# Access Compliance Report

## Public Rights-of-Way

Intersection ID: N/A	Main Street: HOOVER_CREEK_BV	Cross Street: STEELECROFT_PY	Location: SW
ADA ID: 45995389E4CF	Ramp Type: Perp	Initial Pass/Fail: Fail	Overall Compliance: No
Severity Score: 12.5			
Codes/Mitigation Info/Possible Solution		Field Measurements/Component Compliance

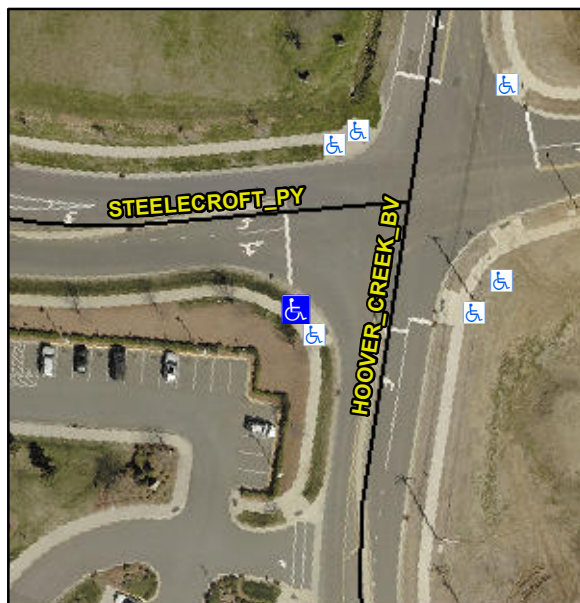
**Not Found, R304.2.2**

Compliance	Description	Data	Compliance	Description	Data
N/A	Ramp Length (in)	94.0	No	Ramp Slope (%)	8.5
Yes	Ramp Width (in)	48.0	Yes	Ramp XSlope (%)	1.3
N/A	Flare Type LT	N/A	N/A	Flare Type RT	N/A
N/A	Flare Slope LT (%)	N/A	N/A	Flare Slope RT (%)	N/A
N/A	Flare Traversable LT?	N/A	N/A	Flare Traversable RT?	N/A
N/A	Landing Length (in)	N/A	N/A	DWS Provided?	N/A
N/A	Landing Width (in)	N/A	N/A	DWS Contrast?	N/A
N/A	Landing Slope (%)	N/A	N/A	DWS Length (in)	N/A
N/A	Landing X Slope (%)	N/A	N/A	DWS Full Width?	N/A
N/A	Landing Curb? (Y/N)	N/A	N/A	DWS Offset (in)	N/A
N/A	Shared Landing?	N/A			
N/A	Gutter Ponding?	N/A	N/A	Gutter Slope (%)	N/A
N/A	Gutter Lip Ht (in)	N/A	N/A	Gutter X Slope (%)	N/A
N/A	Painted X Walk1?	No	N/A	Painted X Walk2?	N/A
	X Walk 1 Direction	To NE		X Walk 2 Direction	N/A
N/A	X Walk 1 Width (in)	N/A	N/A	X Walk 2 Width (in)	N/A
	X Walk 1 Slope (%)	1.9		X Walk 2 Slope (%)	N/A
	X Walk 1 X Slope (%)	0.2		X Walk 2 X Slope (%)	N/A

**Remove & Replace Entire Ramp.**
